To: T10 Technical Committee
From: Rob Elliott (elliott@hp.com)
Date: 6 June 2007
Subject: 07-263r0 SAM-4 SCSI Initiator Port and Target Port capabilities attributes

Suggested changes to SAM-4

Figure 1 — SCSI Port class diagram [\[modified to add tons of attributes\]](#)

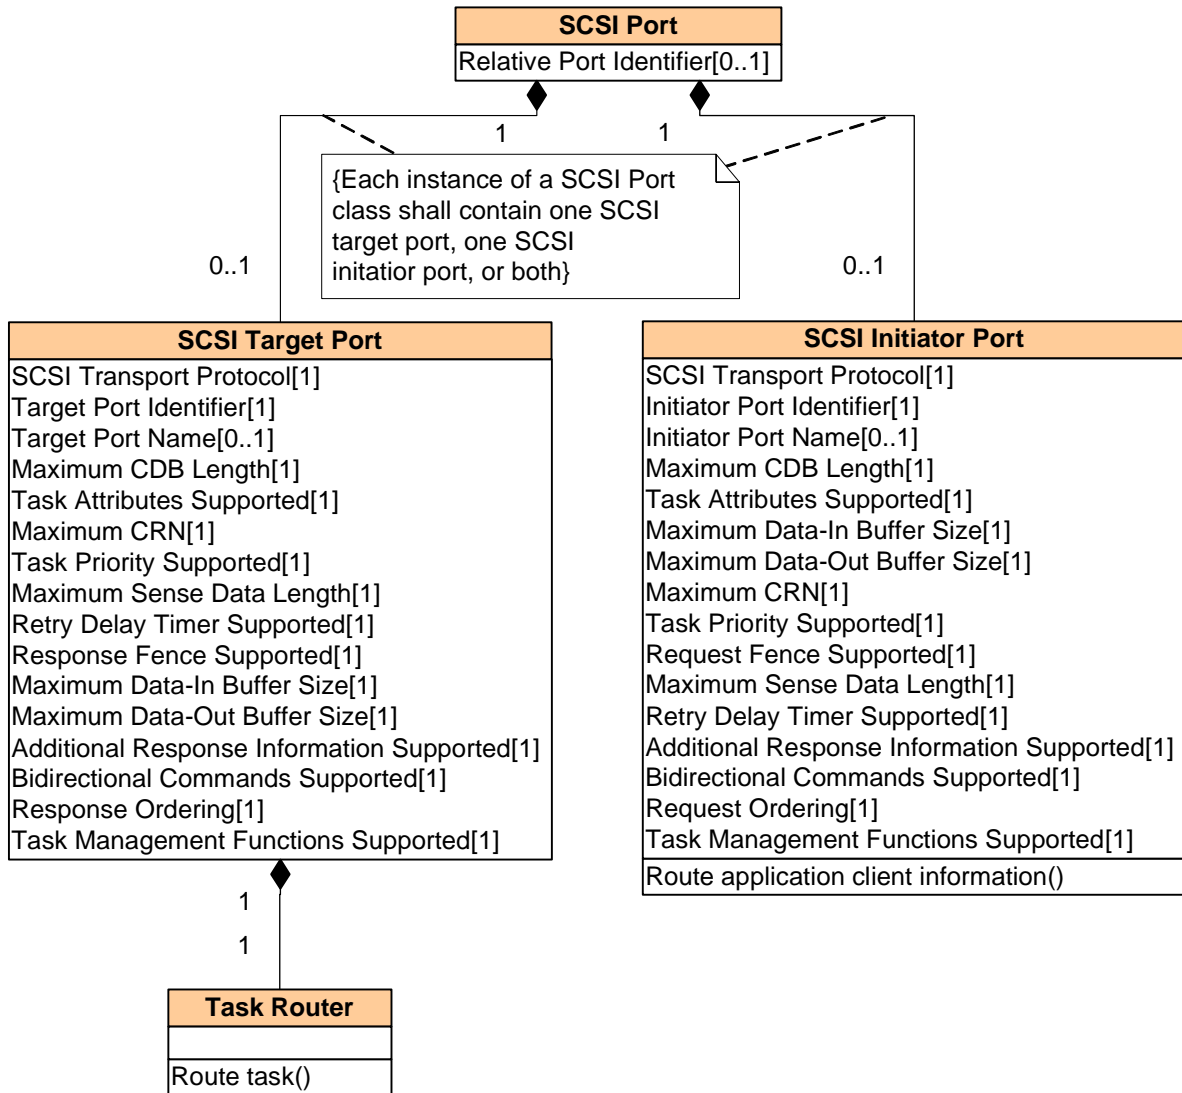
A SCSI Port class (see figure 18) contains the:

- a) SCSI Target Port class (see 4.5.6) that contains the:
 - A) Task Router class (see 4.5.8);
- b) SCSI Initiator Port class (see 4.5.7.1); or
- c) both.
